29 New End  
London NW3 1JD

Basement Impact Assessment  
Audit

For  
London Borough of Camden

Project Number: 12336-80

**Figure 1: Select SPT-N60 profile**

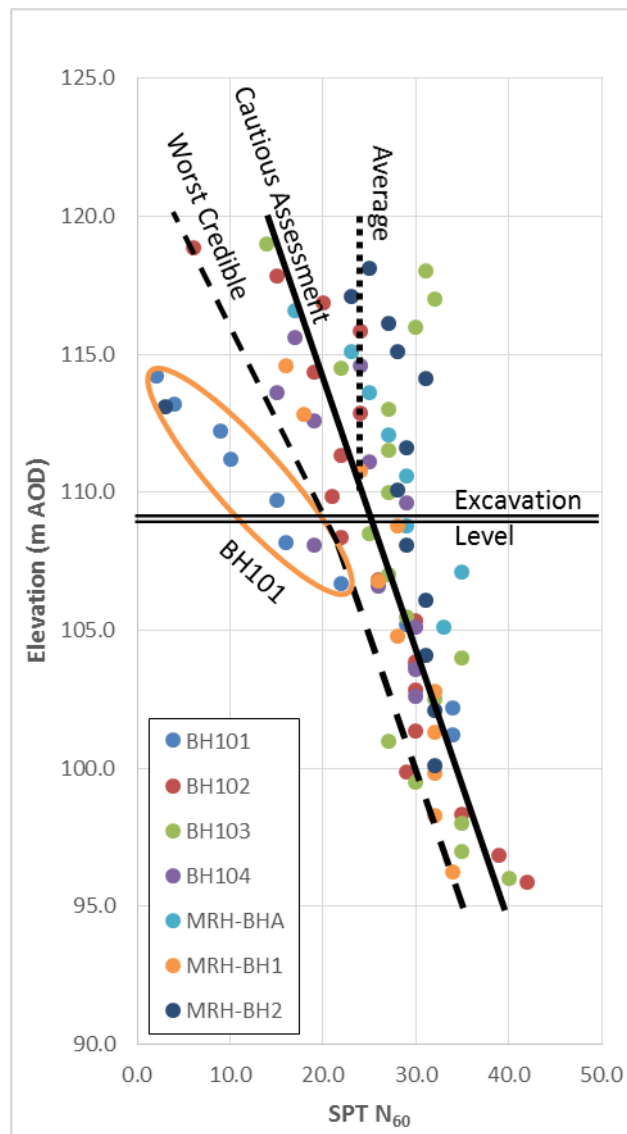
*Item 2: It is understood that the outcomes of the Plaxis analysis were normalised against the excavation depth. It should be clarified what was assumed for H in figure 4.2 of the GMA report, as it is not the same for prediction curves for installation and excavation. Also, it should be confirmed what depth was assumed for retaining walls piles;*

You refer to cohesive soils below 102m OD. The factual information supplied by SCL shows a significant cohesive layer below 112m OD. Can you please clarify the ground model (that presented in Tables 2.1 and 2.2 does not give elevations and Fig 2.3 is difficult to interpret).

Is there a possible explanation for the 'outlier' in the data exhibited by BH101? It is difficult to ignore it if it cannot be explained.

Figure 1 provides a review of the SPT  $N_{60}$  results used to develop the adopted design profile. It is considered that the adopted design line presents a cautious assessment of the variation of SPT  $N_{60}$  with elevation, particularly with regards to the results within the retained height of the excavation. Notably, BH101 tended to indicate a lower trend, though it was considered to be an outlier for the assessment.

**Figure 2: Damage category on the assumption of a “Low Stiffness Wall” at Lawn House.**

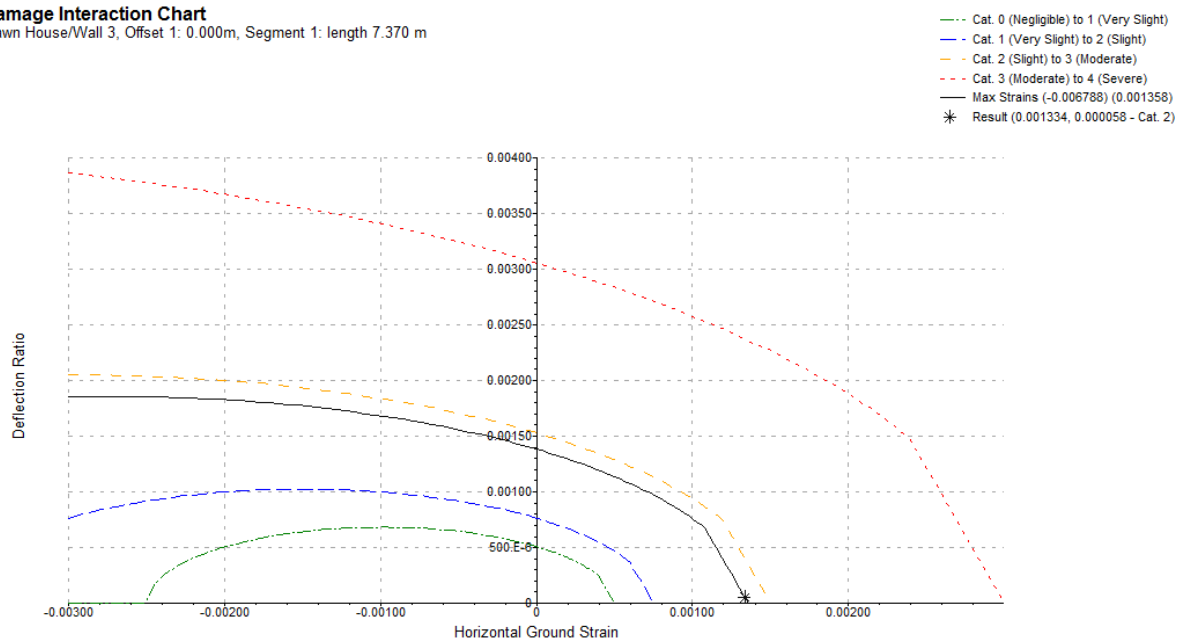
*Item 5: Temporary works drawings appear to show sheet pile walls to act as a cantilever (e.g. section A, stages 2A and 2B). It should be confirmed whether this has been incorporated into the assessment;*

Notwithstanding the above, a simplified sensitivity check on the effect of adopting a “Low Stiffness” wall was assessed as part of the GMA for Lawn House. As shown in Figure 2, the maximum predicted Damage Category is Category 2 – Slight. This is within the existing maximum damage category assessed for Lawn House, albeit the position of the damage category coordinate is located further within the Slight damage contour interval.

**Figure 3: Damage Category at Lawn House based on full secant pile installation effects. Overall damage category does not change from existing GMA damage category.**

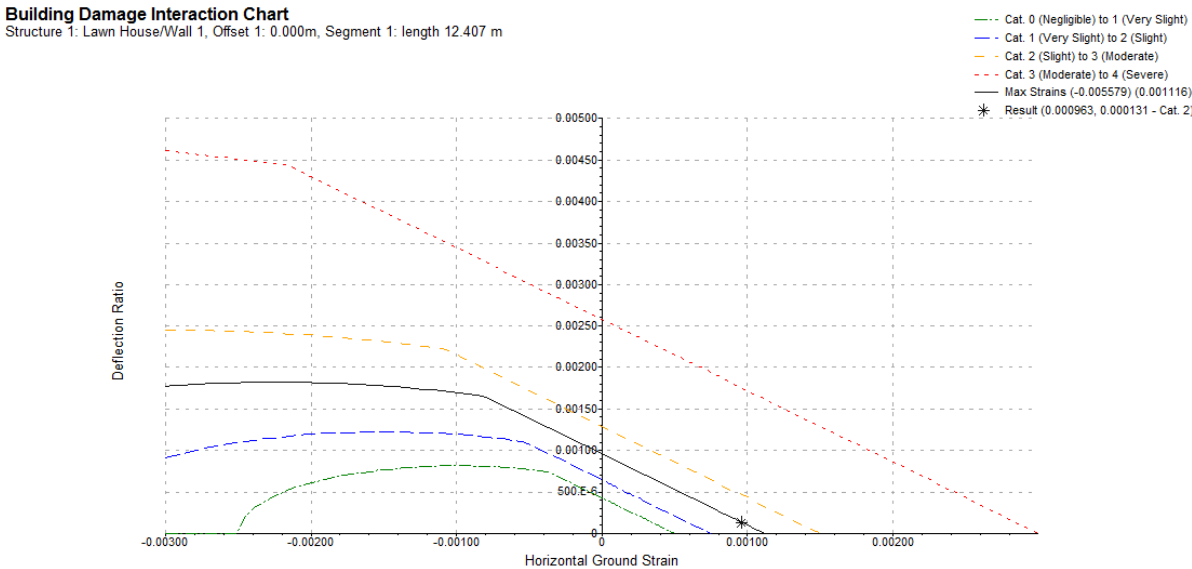
*Item 7: It is noted that the GMA uses the assumption of ‘contiguous piled wall’, whilst the proposed construction consists of ‘secant’ walls that are known to exhibit larger ground movements. It is not considered that this represents a ‘cautious assessment’.*

Notwithstanding the above justification, sensitivity analyses were carried out to assess the damage category predicted at Lawn House if the full secant pile installation effects were adopted for the analyses. The sensitivity analyses indicate that the Damage Category for Lawn House (previously identified to be the most critical structure in terms of building damage category) remains within the predicted Category 2 – Slight range (Figure 2). Albeit, whereas previously the damage category identified in the GMA was estimated to be straddling the Category 1/Category 2 boundary, the damage coordinate is now centred within the Slight damage range. Nevertheless, there does not appear to be orders of magnitude differences in ground strain and thus building damage, due to the selection of a much more conservative pile installation effect.
